BUTTERMILK FALLS - SPA EXPANSION
CONCEPT C-3 TYPICAL WALL SECTION
BATHROOM & LOCKER ROOM
STEPHAN FREID AIA ARCHITECT 06.18.14
170 PARK ROW, NEW YORK, NY 10038

A-405

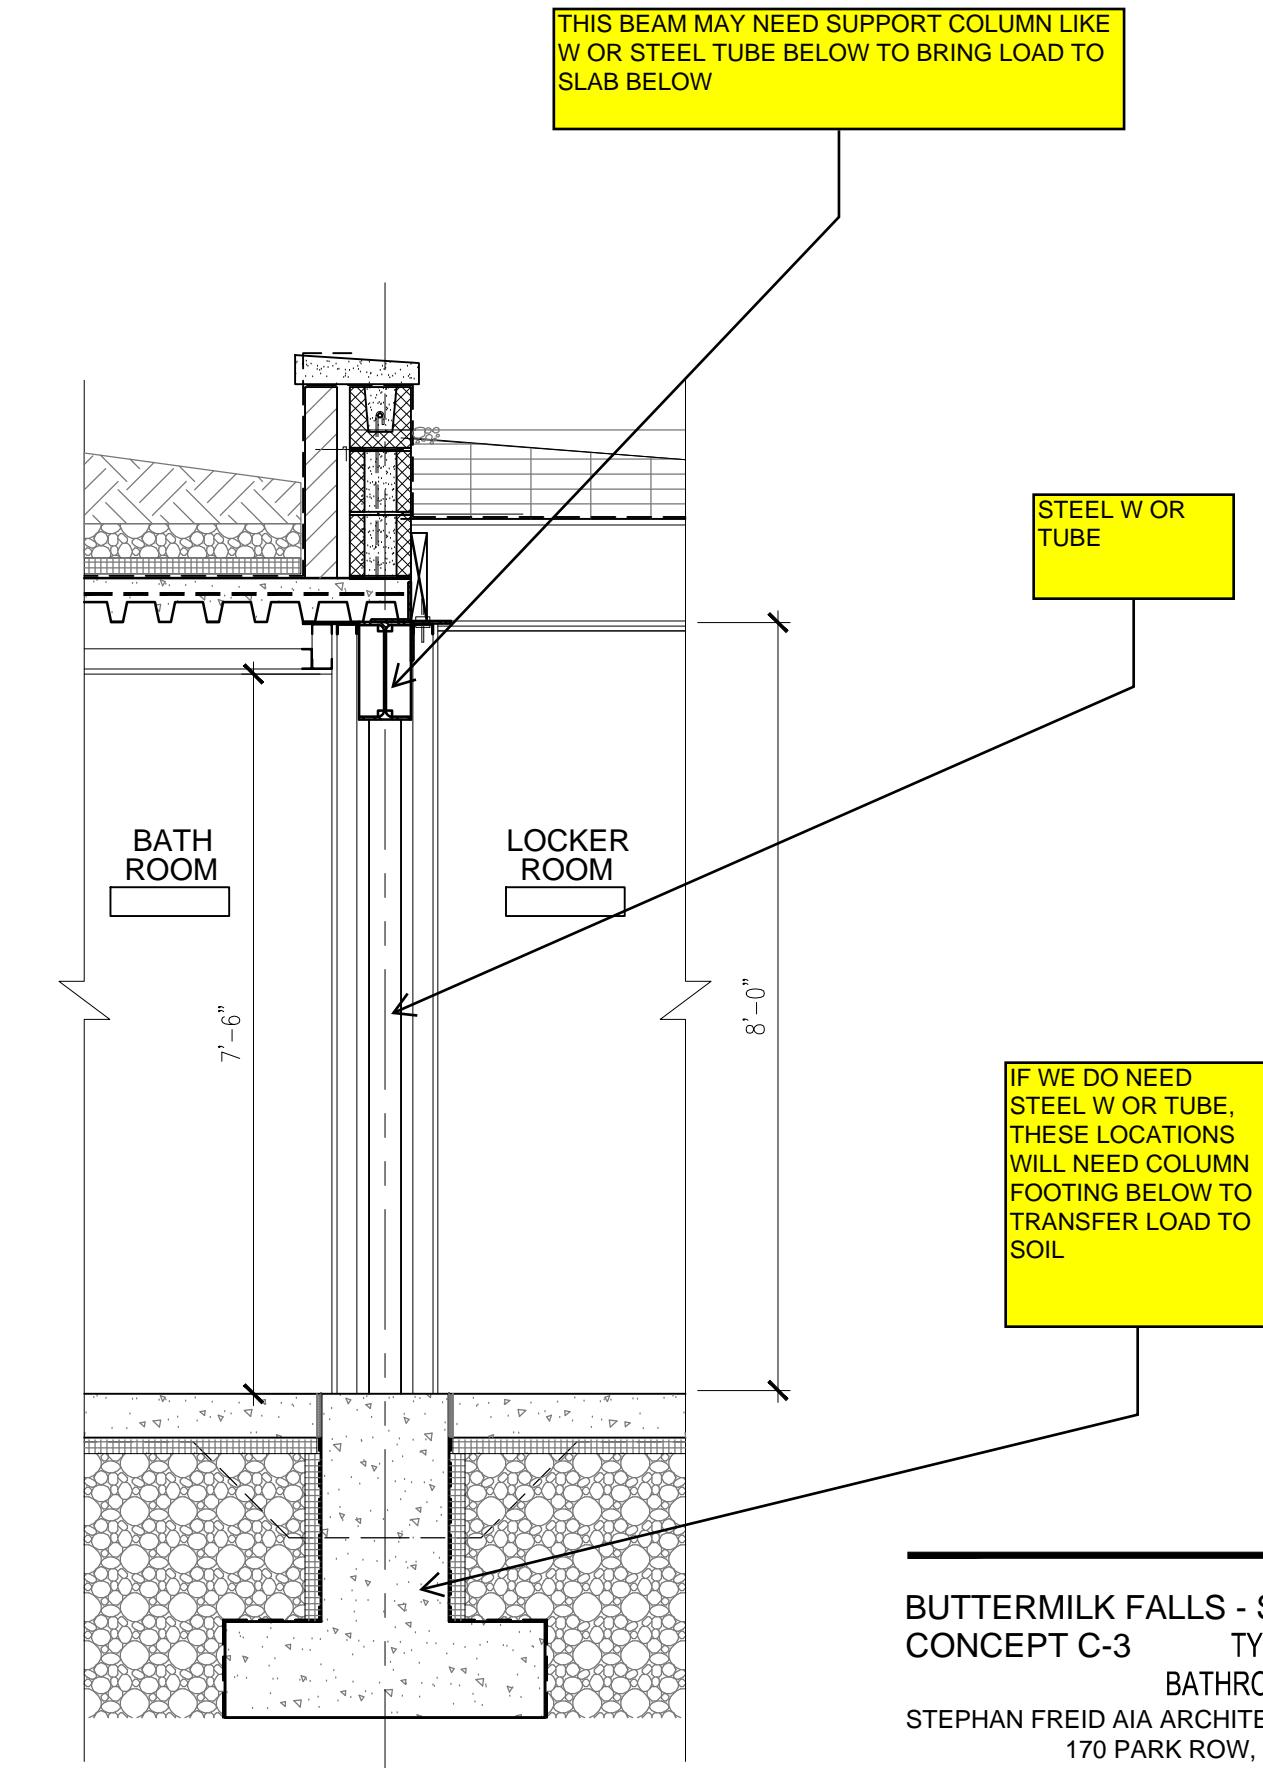
THIS BEAM MAY NEED SUPPORT COLUMN LIKE W OR STEEL TUBE BELOW TO BRING LOAD TO SLAB BELOW

IF WE DO NEED
STEEL W OR TUBE,
THESE LOCATIONS
WILL NEED COLUMN
FOOTING BELOW TO
TRANSFER LOAD TO
SOIL
